MEMORANDUM

TO: Readers of May 2005 Edition of San Diego Drainage Design Manual
FROM: County of San Diego Department of Public Works
Date: July 2005
Subject: Changes to San Diego Drainage Design Manual for July 2005 Edition

Changes to San Diego Drainage Design Manual for July 2005 Edition

Figure 5-11:

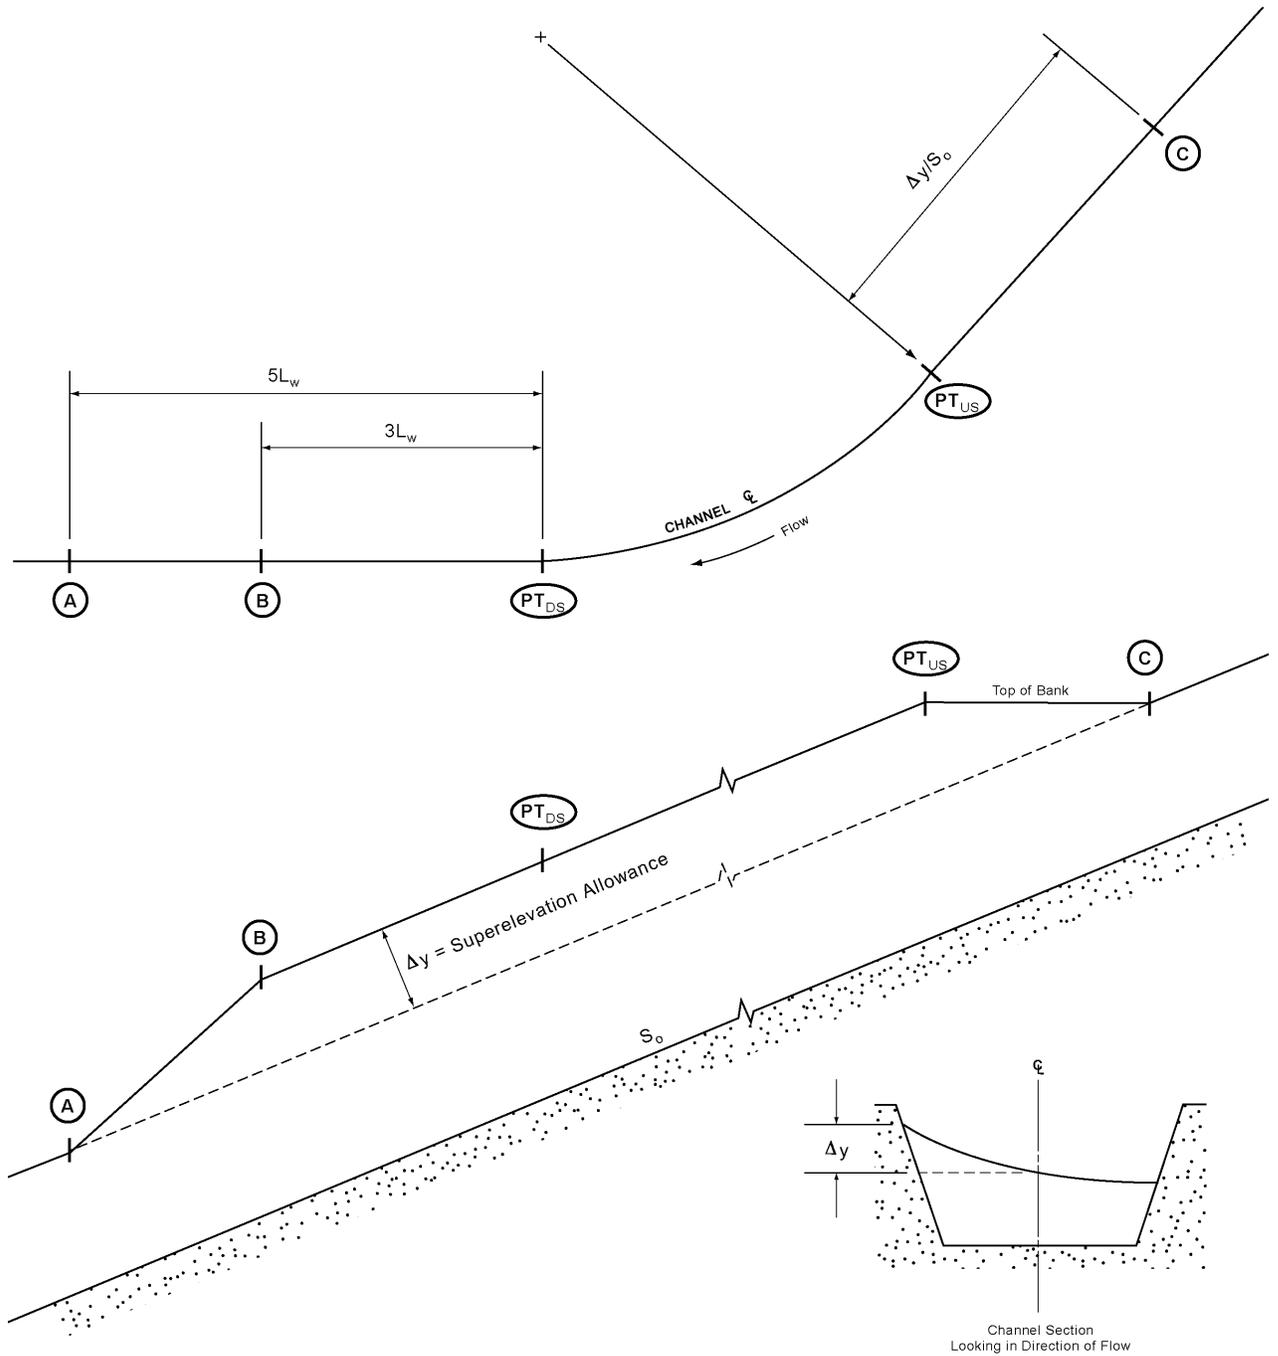
The May 2005 edition of the San Diego Drainage Design Manual distributed at the APWA seminars on May 9, 22, and 23 has been revised and updated in response to comments received at those meetings and subsequent correspondence from the public. This memorandum summarizes the revisions made to the May 2005 edition, providing the context of the revision and adding emphasis (underline and/or strike-out) to demarcate the revised material.

Figure 7-1, Page 7-3:

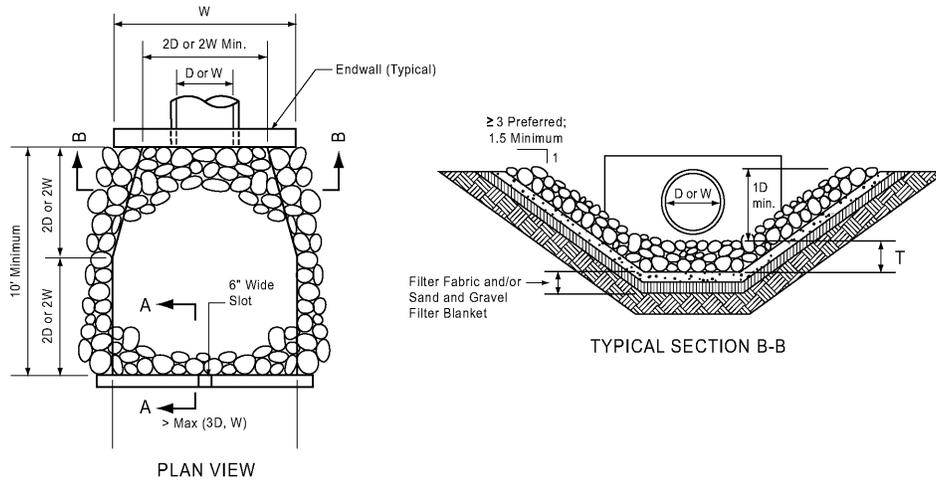
Revised:

NEW Figure 7.2: Impact Basin Energy Loss Nomograph

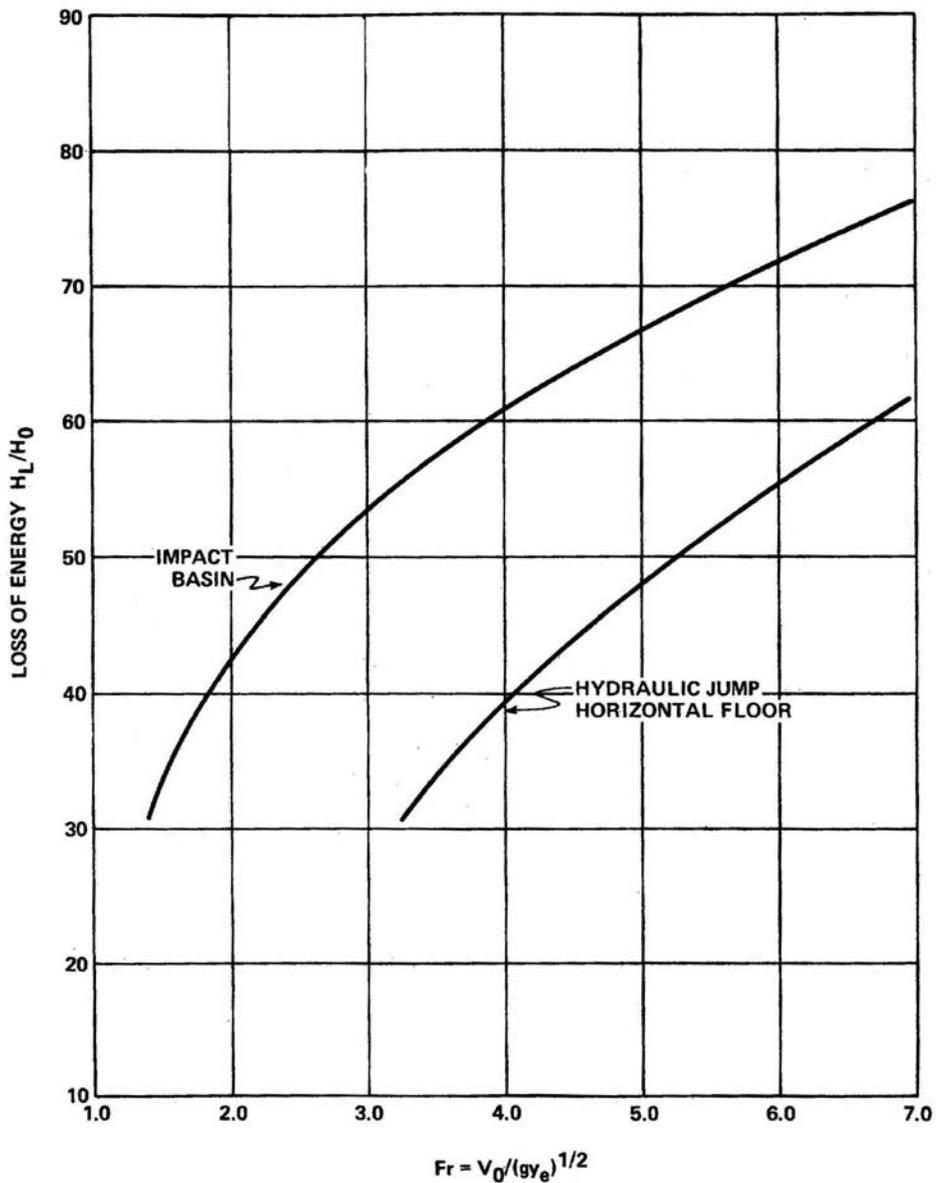
Figure 7-2 (FHWA HEC-14, 1983) provides a nomograph that may be used to estimate the energy loss through an impact basin. This energy loss can then be used to estimate the flow velocity exiting the impact basin. The energy loss through the impact basin is a function of the Froude Number of the flow entering the impact basin, calculated in this case as:

Design standards for the impact basin depicted on San Diego Regional Standard Drawing No. D-41 are based on the USBR Type VI Basin. The original USBR basin has been modified to allow drainage of the basin during dry periods, which enhances the usefulness of the basin in urban environments. The width of D-41 is based on discharge from the storm drain or culvert; this width must be specified on drawings.
